MODERNIZATION
FOR
COLONEL HOWARD NICHOLS SCHOOL
3401 RENEGADE AVE.
BAKERSFIELD, CA 93306

ELECTRICAL SITE PLAN, SYMBOL SCHEDULE AND NOTES

E 1.11

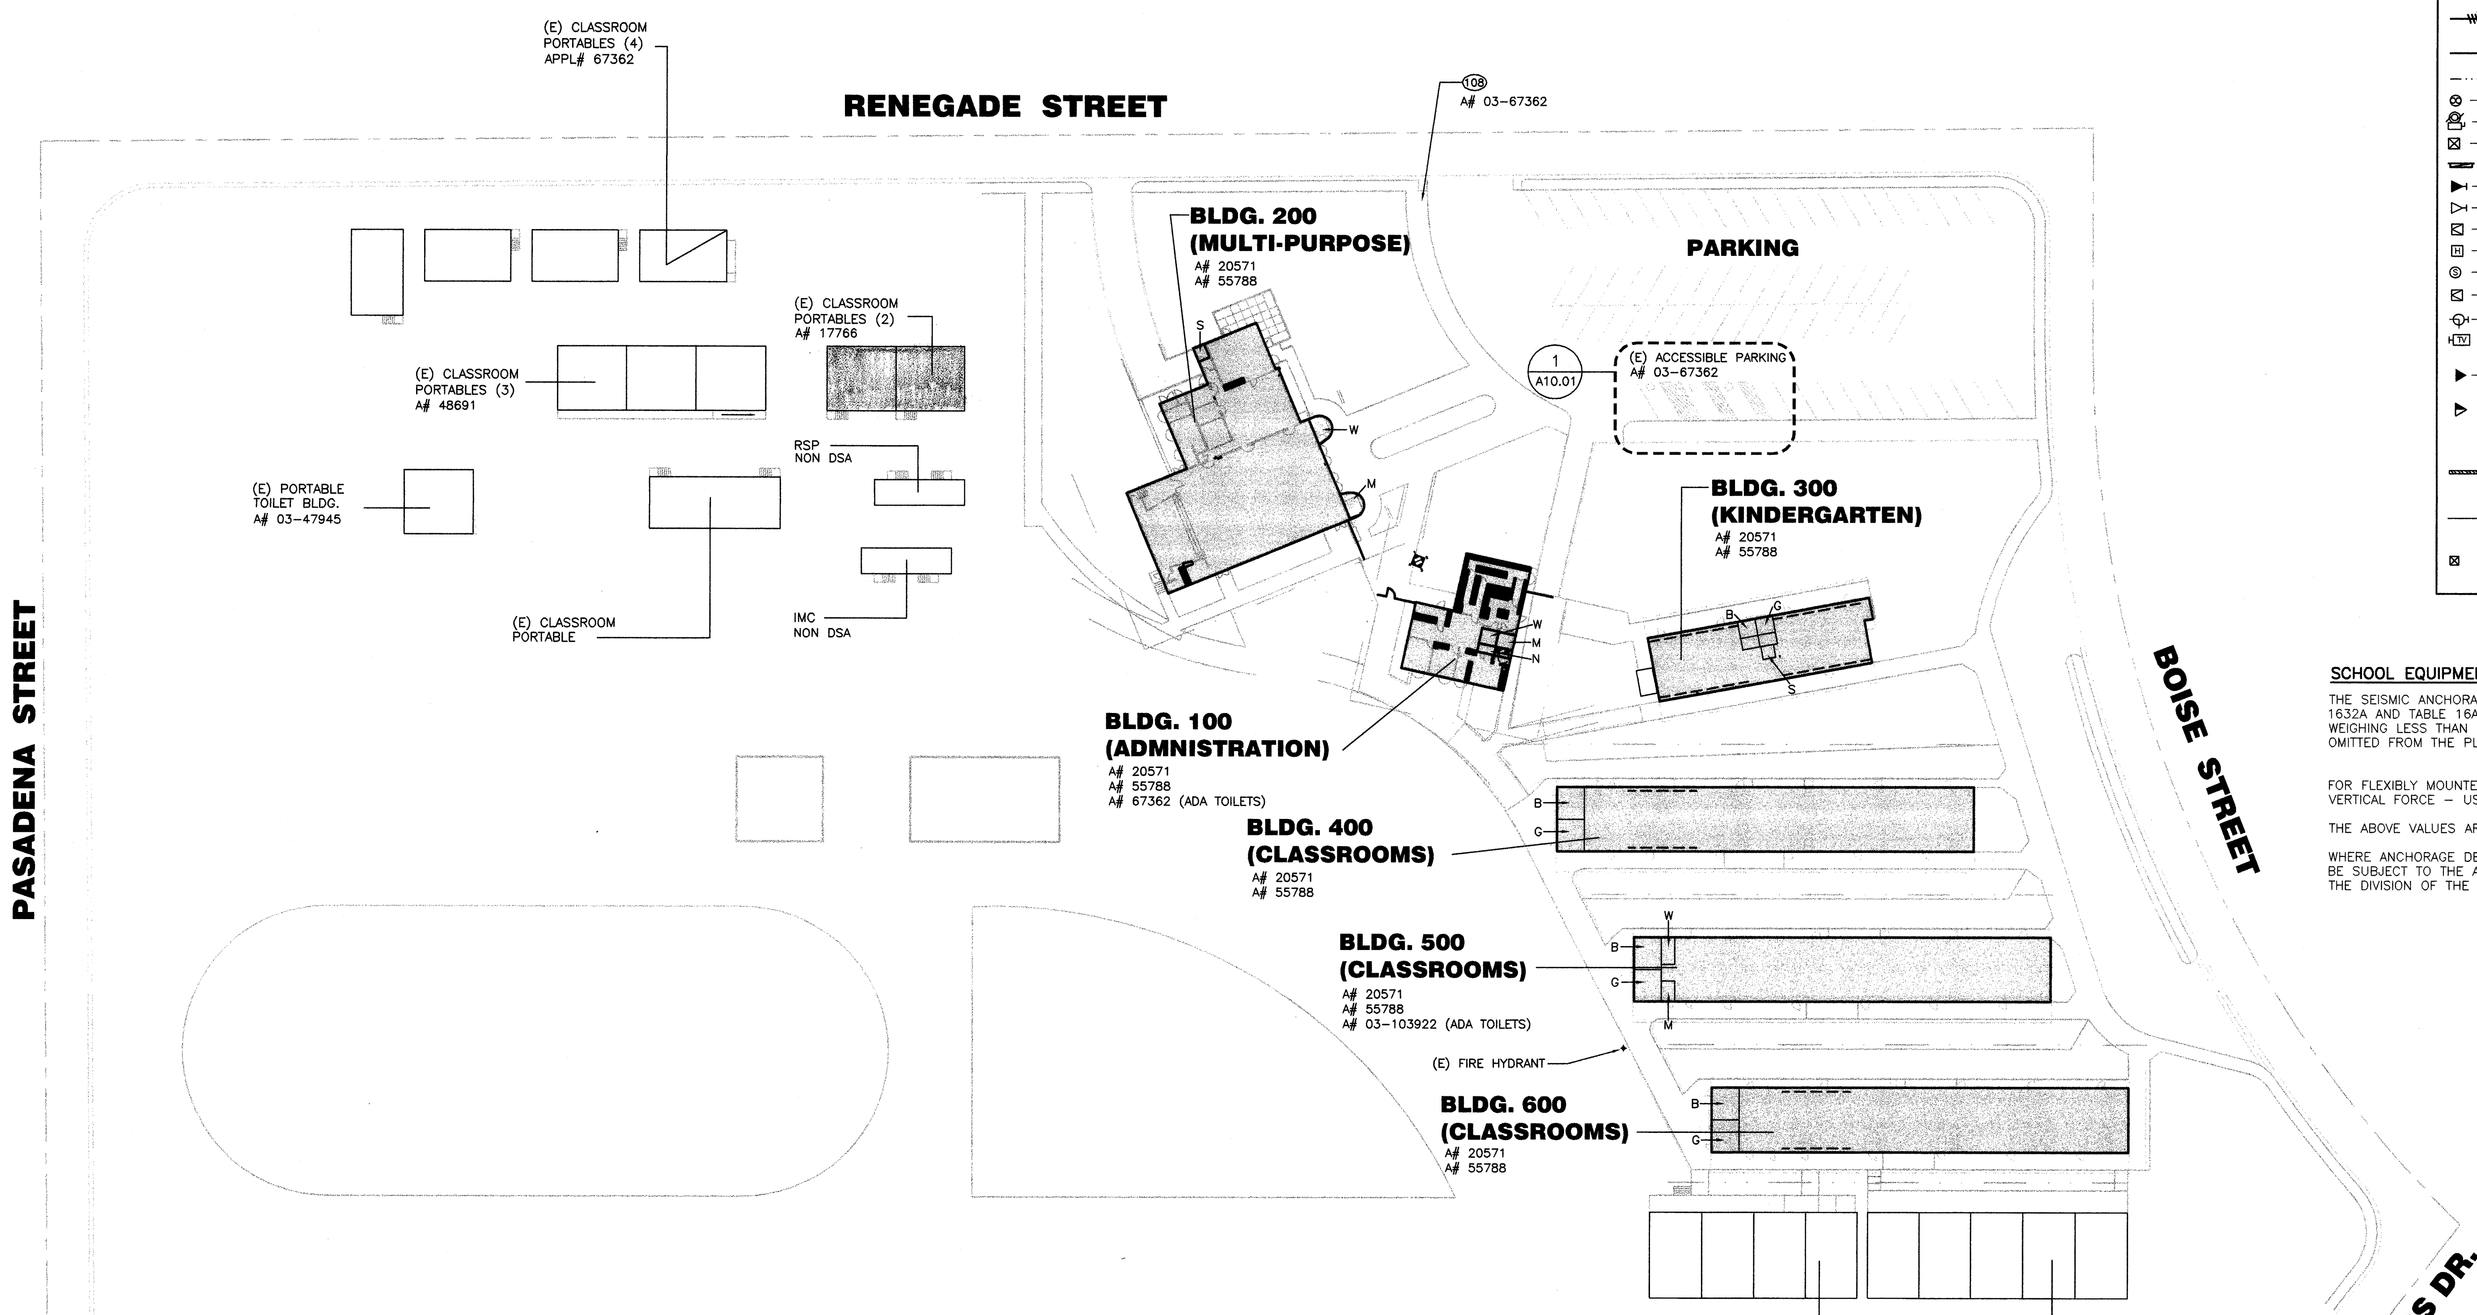
Item (3) Refer to Electrical Drawings, Sheet E1.11, "Fixture Schedule":

CLARIFY all fluorescent lamps shall have a color temperature of 4100K.
